Value Engineering

Final Report

Intake Diversion Dam Fish Protection and Passage Concept Design, Lower Yellowstone Project

July 29, 2002

Figure 8. Obermeyer Weir Photos

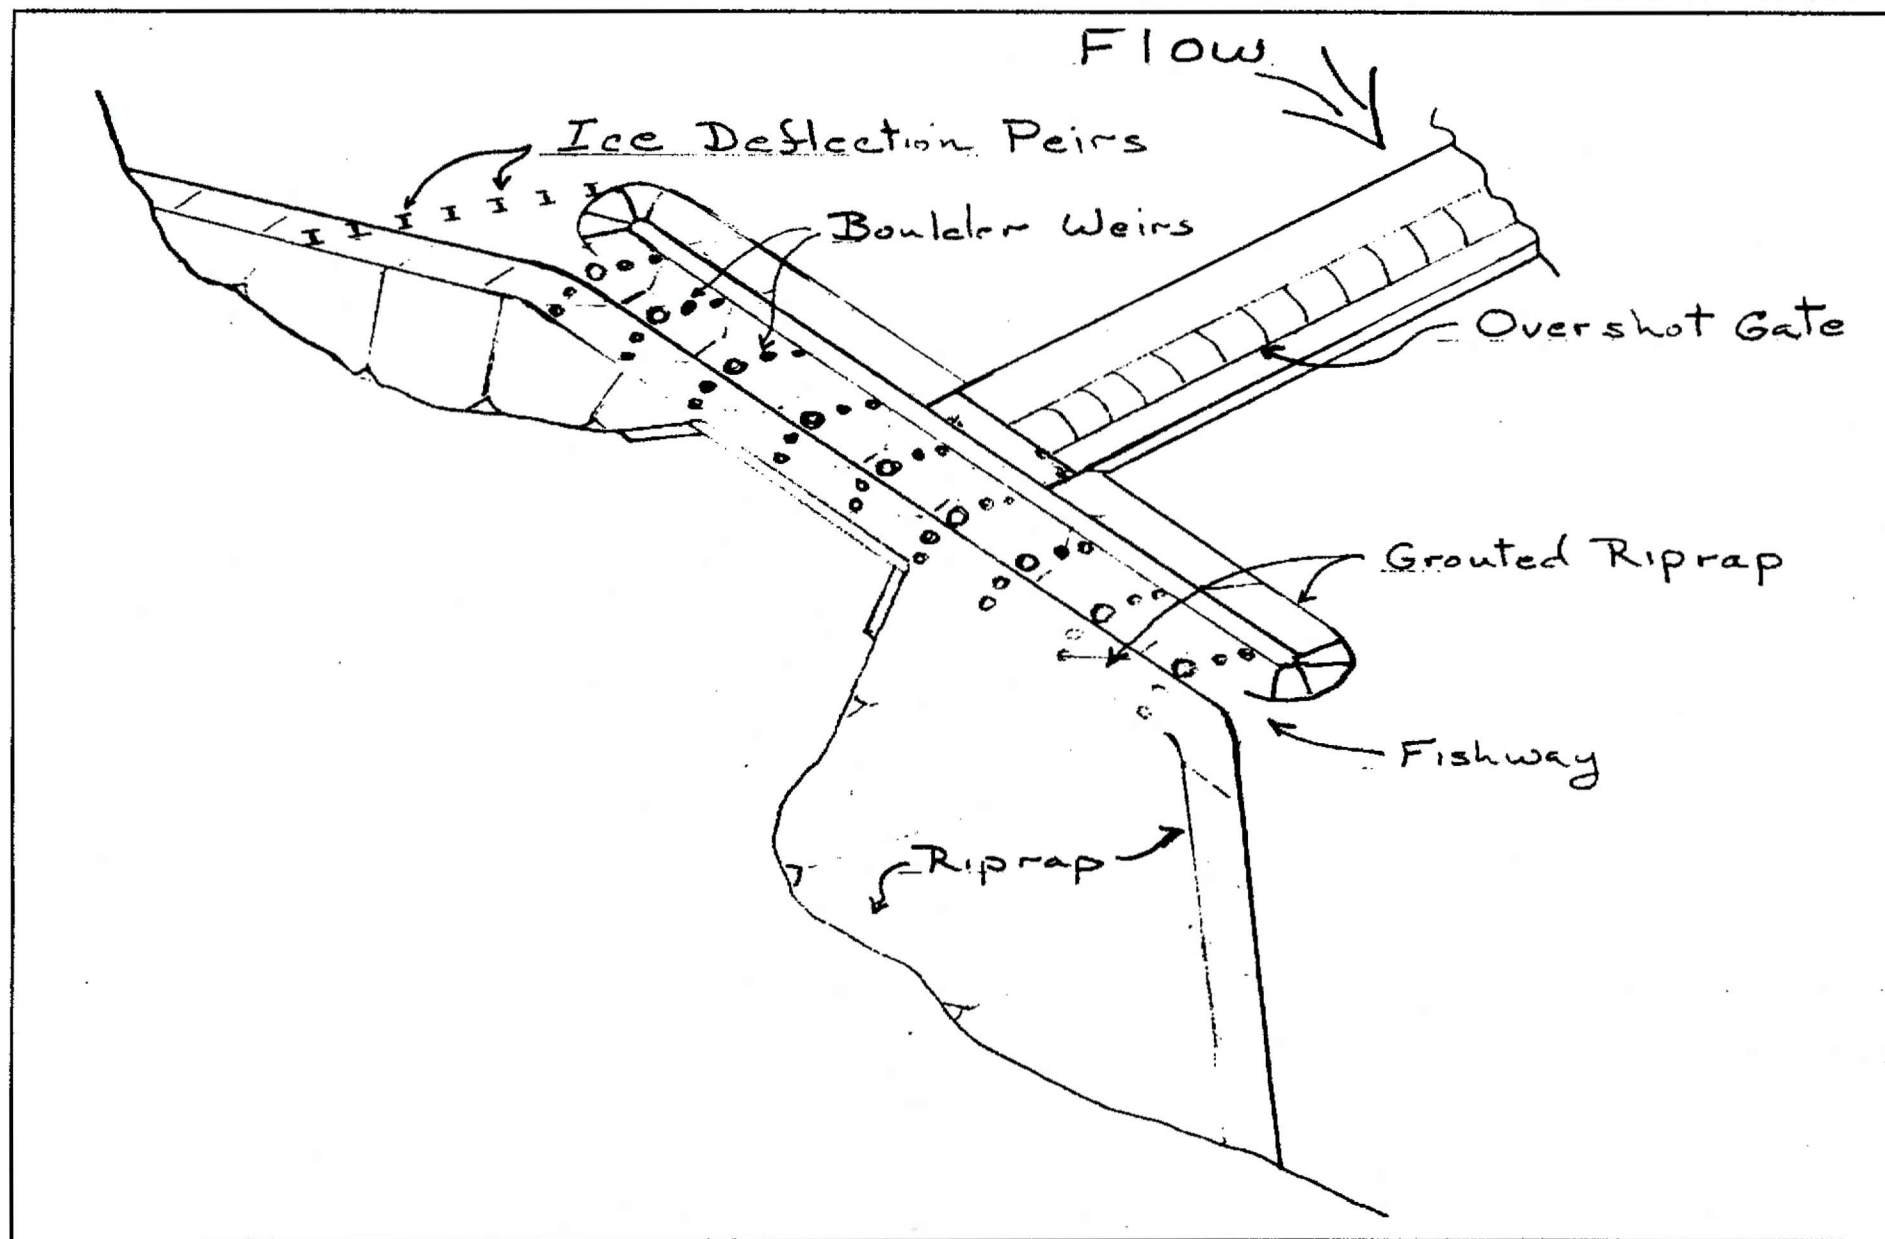
Proposal No. 1. Replace the Dam with a Collapsible Gate System and Fish Passage Channel.

- **Proposal Description:** Because the existing dam has exceeded its design life and requires annual addition of material to the crest to maintain integrity, consider replacing the structure at this opportunity. This proposal would remove the existing dam and replace it with hinged, collapsible gates (Obermeyer style) on a concrete foundation slab. An H piling/bearing should be incorporated to the front and back of foundation slab for added stability. The gates will span about 660 feet across the crest of the dam and will consist of 20 gates that are 33 feet wide. A fish passage channel would be located at or near the south abutment to provide fish passage during low-flow conditions (drought). During high-flow conditions, most or all of the gates could be completely lowered presenting almost no obstruction to movement. As flows begin decreasing in the river, additional gates could be raised, creating sufficient head for diversion of irrigation water. Existing data suggests that the rock that has been deposited on the dam crest through maintenance and has washed downstream has contributed to the impediment of passage of fish such as the pallid sturgeon. Rock that has washed out from the existing structure would be removed and incorporated into the project where applicable.

- **Changes from the Baseline Concept:** Removes and replaces existing dam with hinged weir and fish passage channel. This proposal is likely to increase opportunities of providing fish passage for a wider variety of native fish species over the baseline.

Figure 10. Screen Sill Section

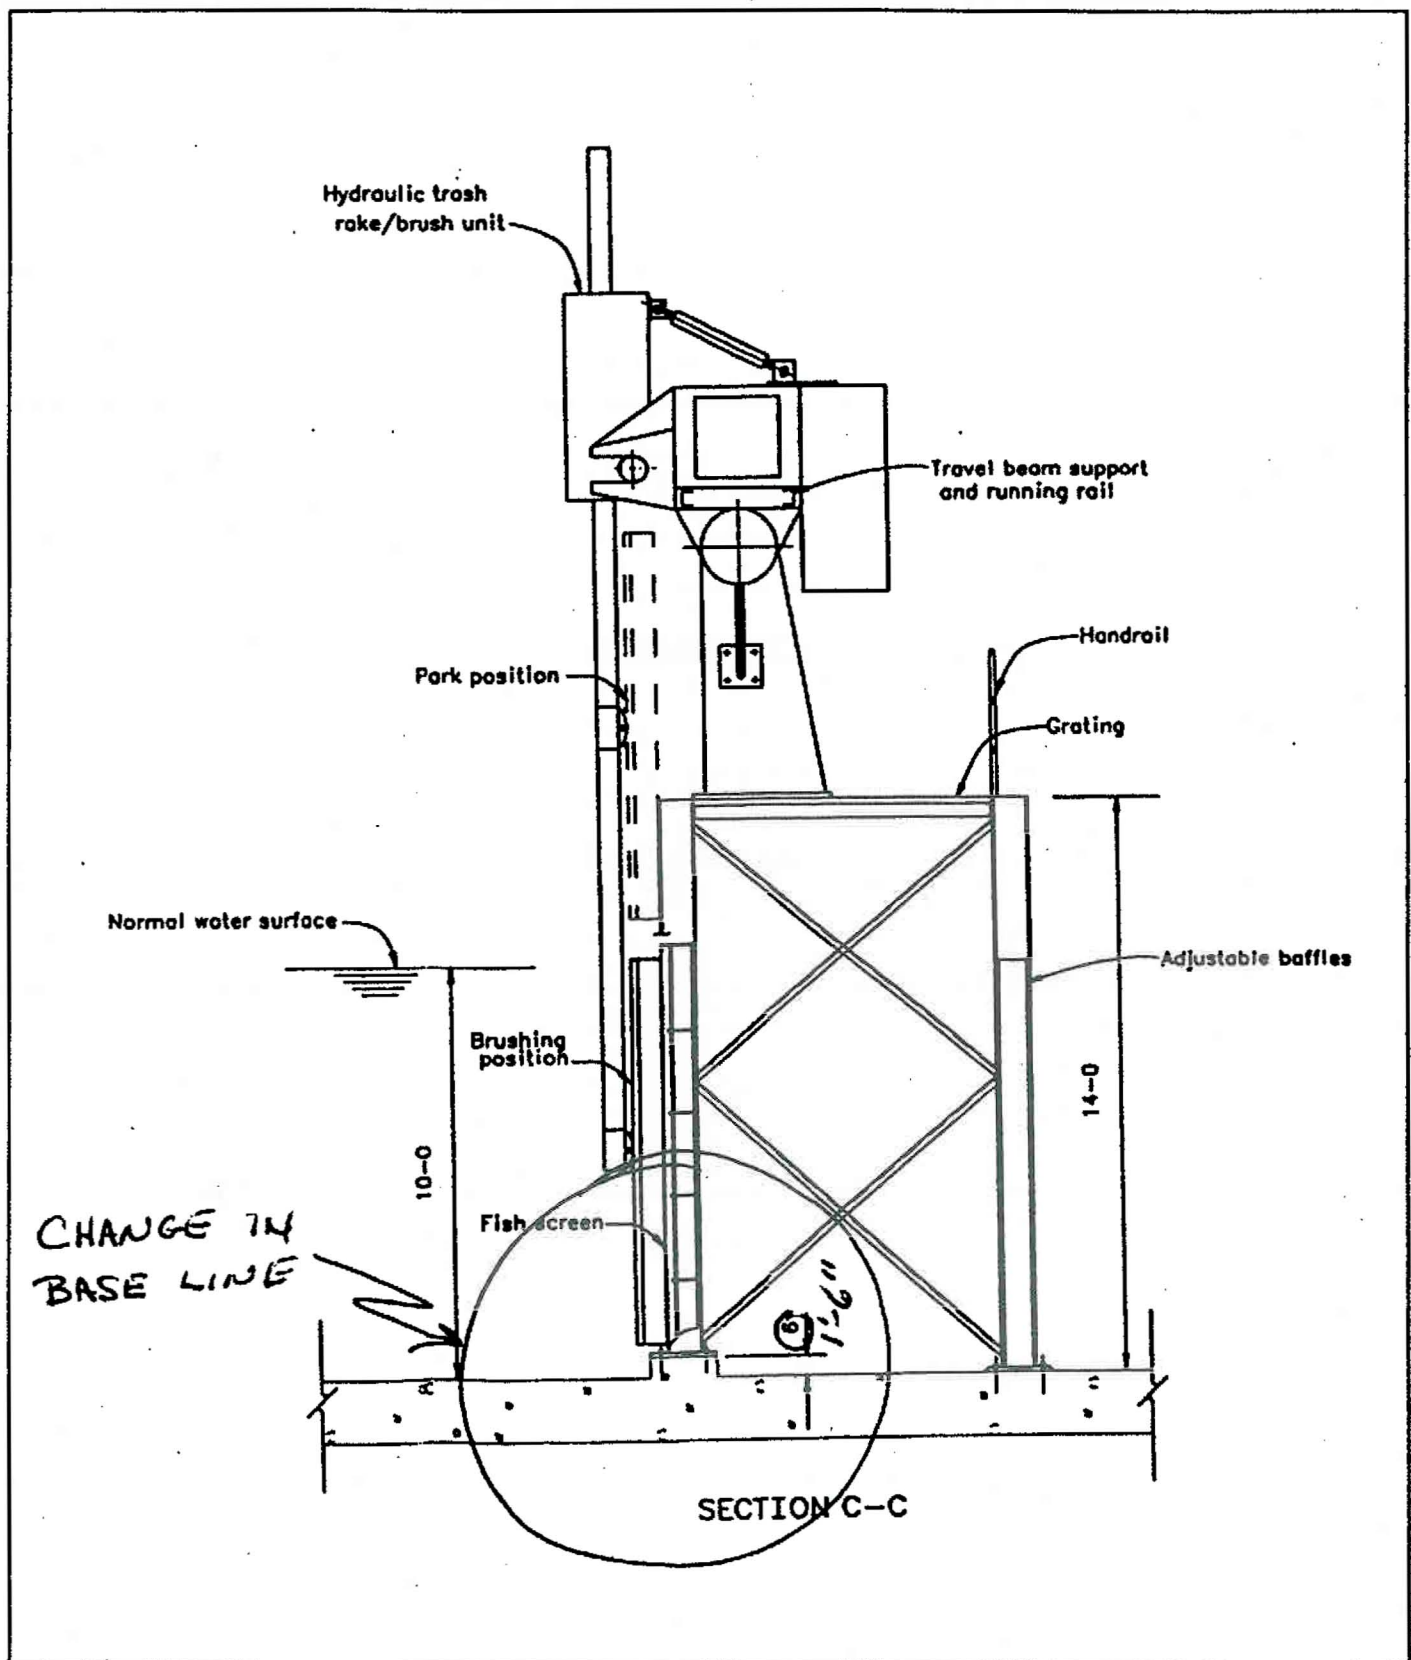
Proposal No. 2. Increase Height of the Concrete Sill under Screens to 18 Inches.

- Proposal Description: This proposal is to change the height of the concrete sill along the base of screen array from 6 inches to 18 inches, primarily to reduce exposure of bottom swimmers to the screens and to prevent silt buildup from impeding the screen cleaning brush. To keep the same wetted screen area, it will be necessary to substitute 37 - 9-foot by 9-foot screens in place of the 30 - 10-foot by 10-foot screens, lengthening the screen array by 33 feet.

- Changes from the Baseline Concept: Total screen length will increase from 300 to 333 feet. As a result, the constant width section length will increase from 350 to 380 feet. The angle of the screen array to the flow will decrease from 9.8 to 8.9 degrees.

Figure 11. Plan of Trap

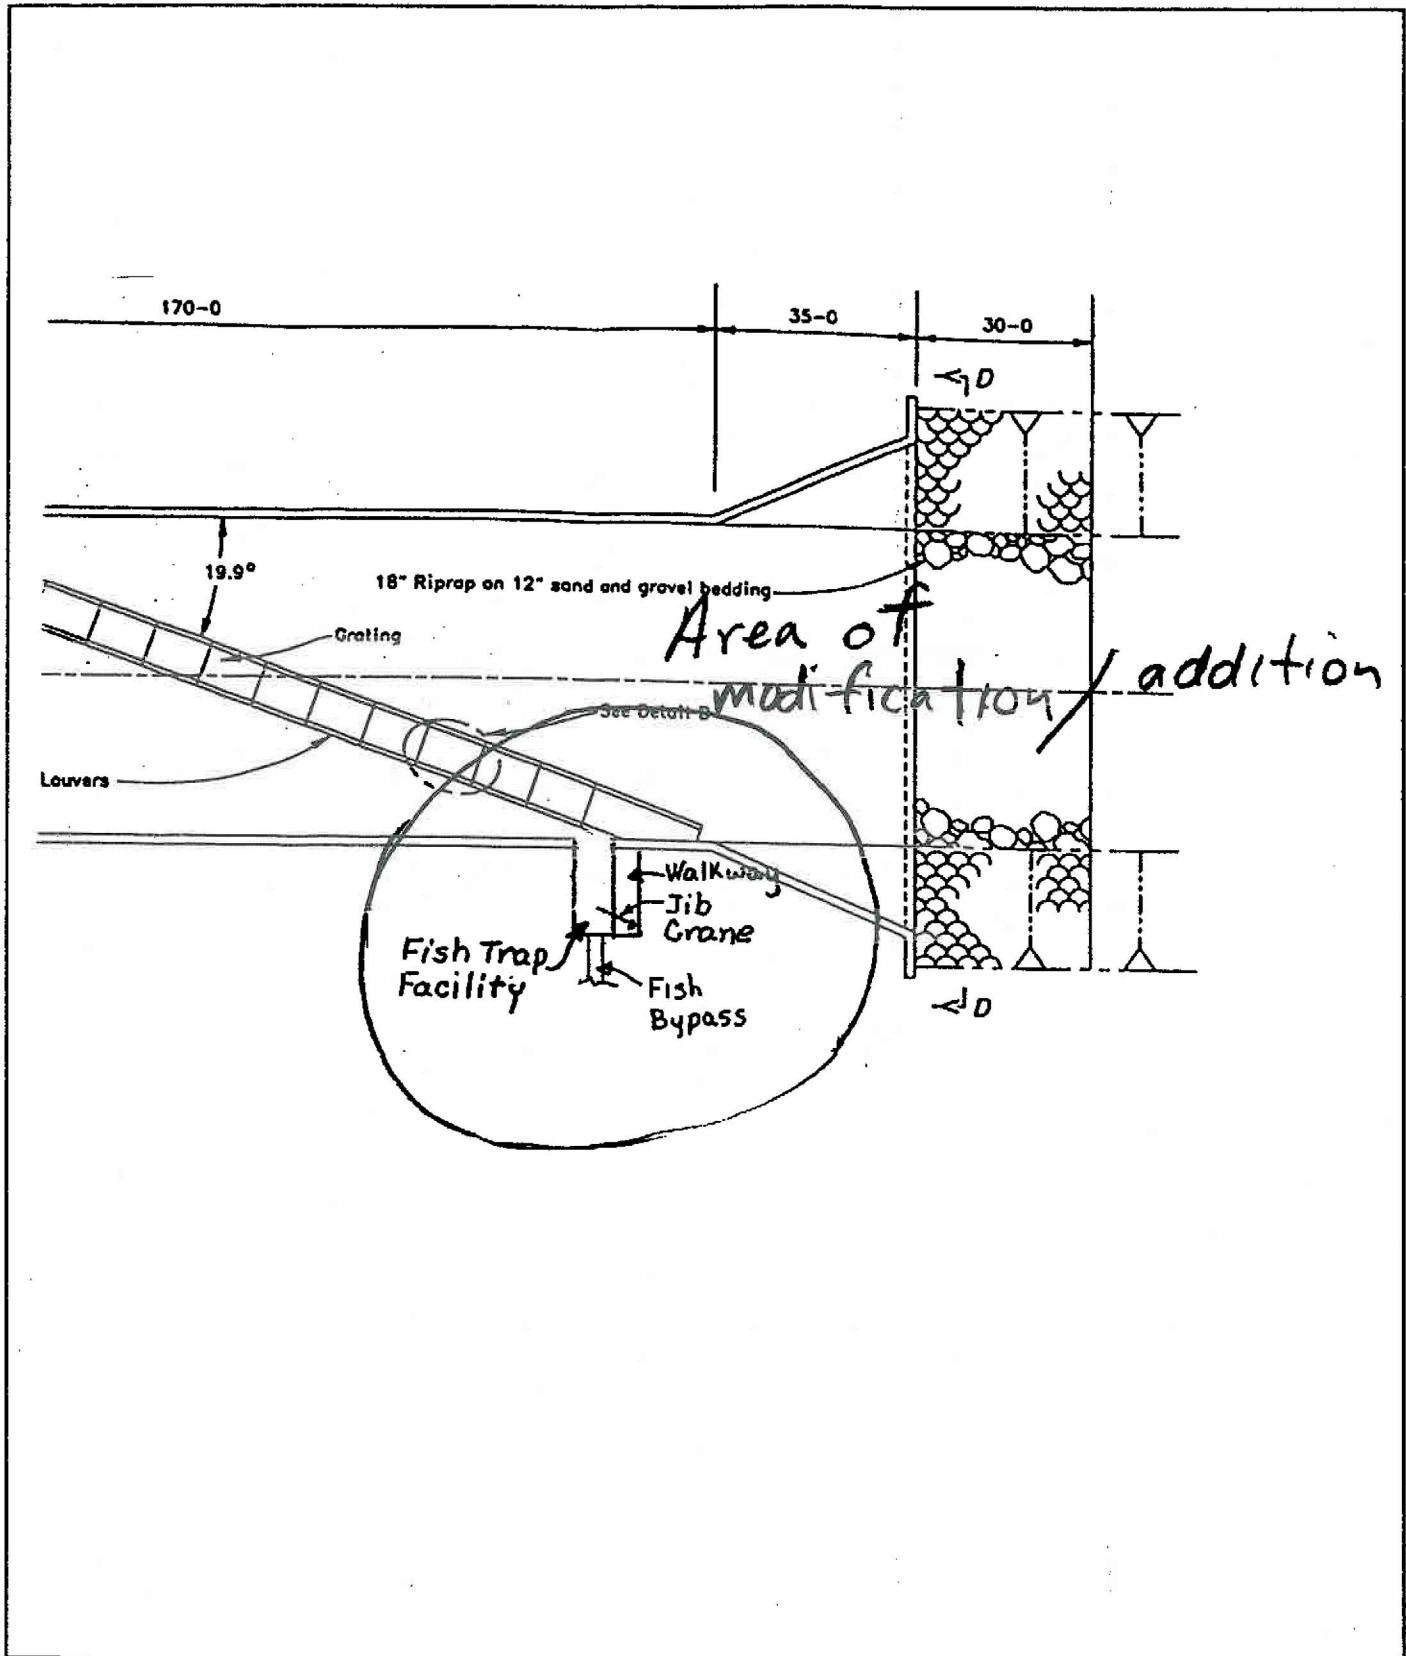
Proposal No. 3. Build a Fish Trapping Facility into the By-pass Area of Intake Canal Screen.

- Proposal Description: This proposal is to add a fish collection area and trapping device at the downstream end of the screen array, close to the entrance to the by-pass. The trap would be submerged in the by-passed flow for brief intervals to collect live fish for monitoring and research purposes.

- Changes from the Baseline Concept: The baseline does not include a trapping facility. Changes include structural modification at bypass entrance and addition of a hoisting device.

Figure 14: Plan View of Walkway in Front of Screen

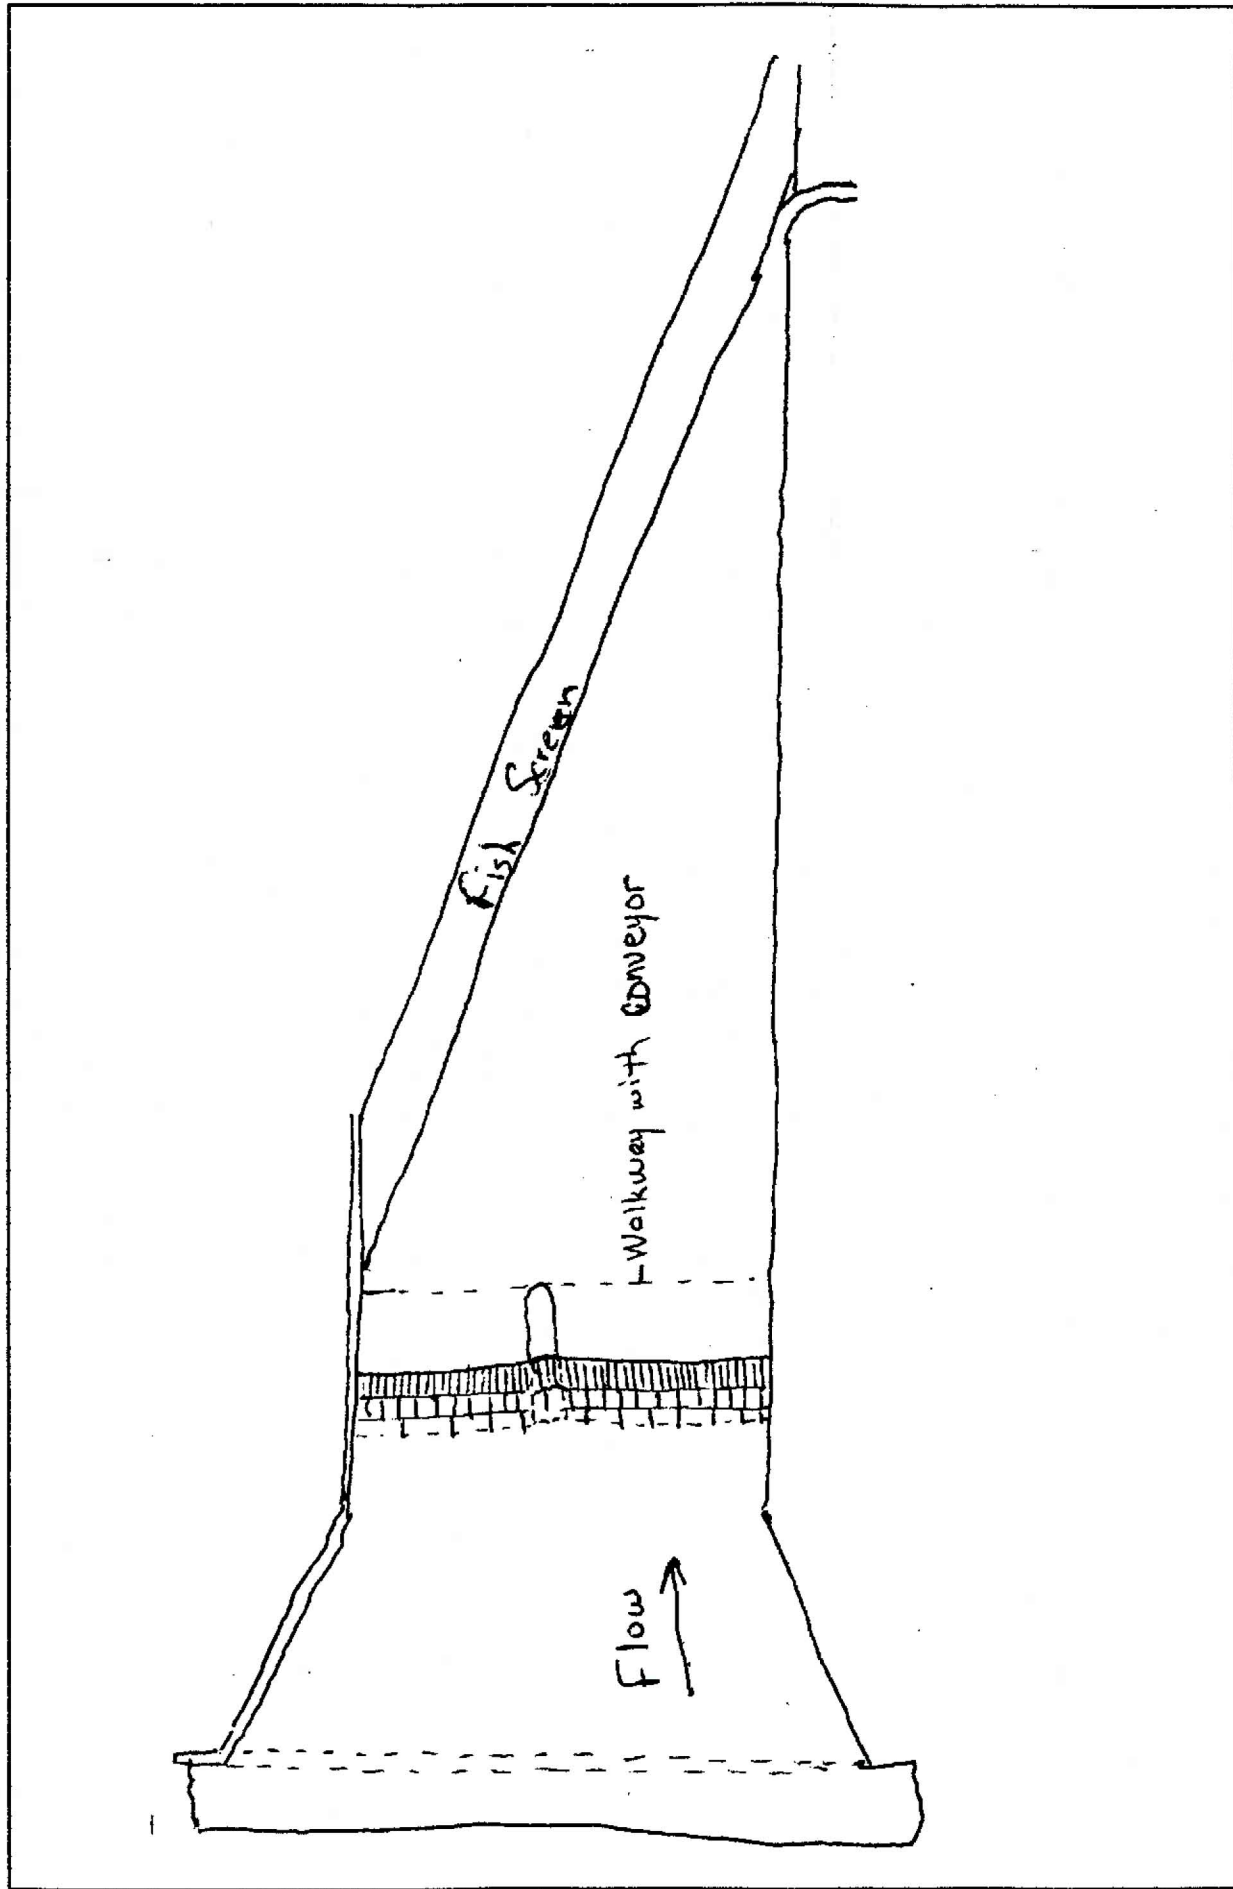
Proposal No. 4. Install Trashrack in Front of the Fish Screen.

- Proposal Description: This proposal would install a trashrack upstream of the fish screen to collect and remove large debris that is entrained through the primary intake. The rack would consist of a structure with a middle pier with variable bar spacing to provide the greatest opportunity for fish passage. The portion of the rack in the upper half of the water profile would consist of bars set vertically with a 4-inch spacing, the mid-section of the water profile would have a spacing of about twelve inches and the lower 3-foot portion would have a spacing of approximately 24 to 48 inches. A hydraulic trash rake and conveyor would be included to provide a mechanical means of removing the debris for collection and removal.

- Ways to Implement: None identified.
- Changes from the Baseline Concept: This proposal would be the addition of a trashrack to increase the effectiveness of the fish screen to function by removing the larger debris.
